Traffic Study:

ALTERNATE 1

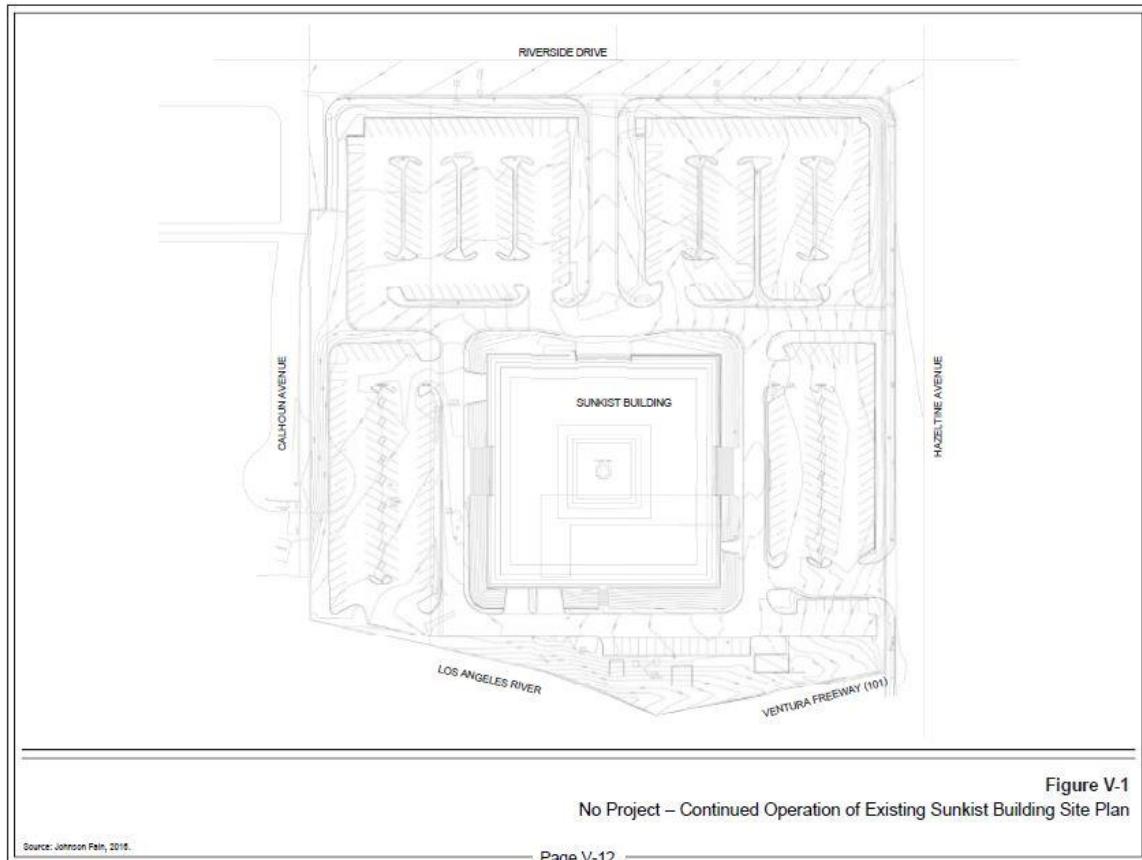
Comment: We feel the community would approve this alternative.

ALTERNATE 2

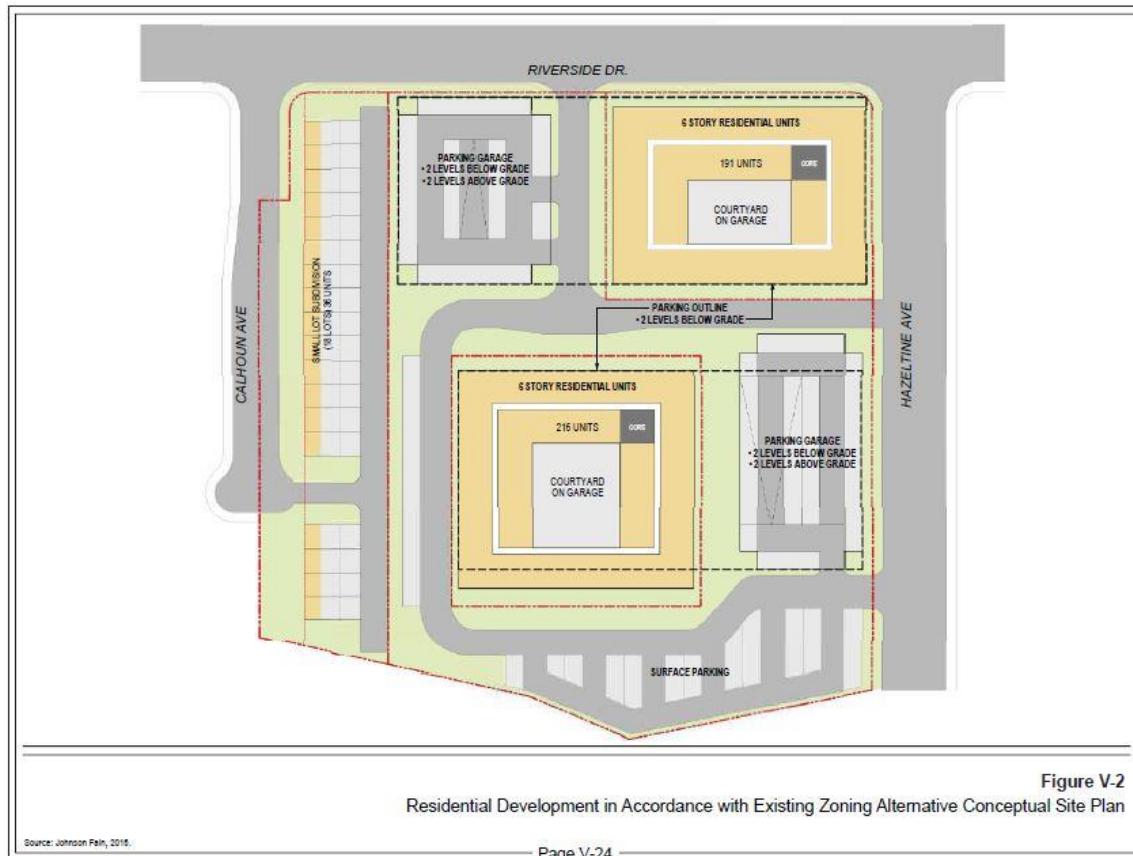
Comment: Existing Zoning does not allow for structures along Calhoun and does not allow for above grade parking structures.

ALTERNATE 5

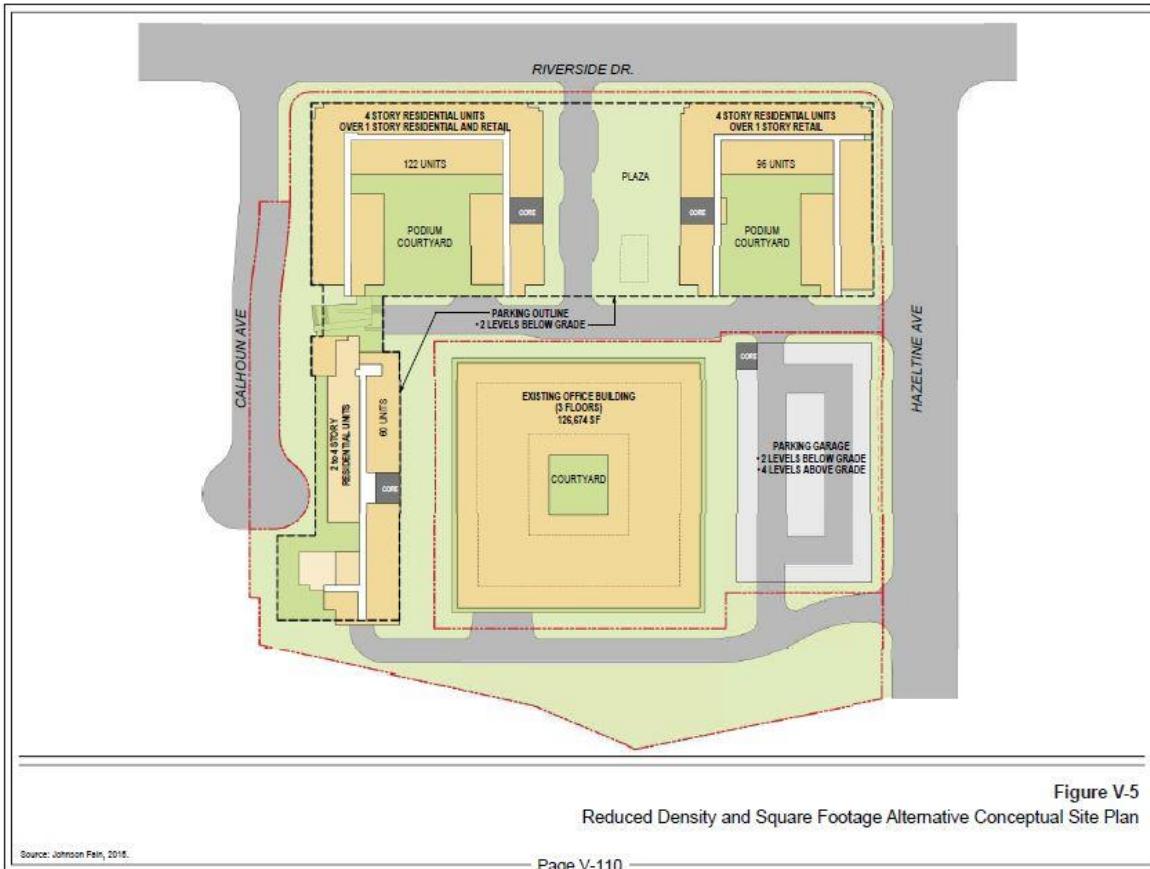
Comment: A Reduced Density Alternative should have the square footage based on something. We recommend basing the square footage on the amount of parking that is in keeping with the existing PB-1L zoning.
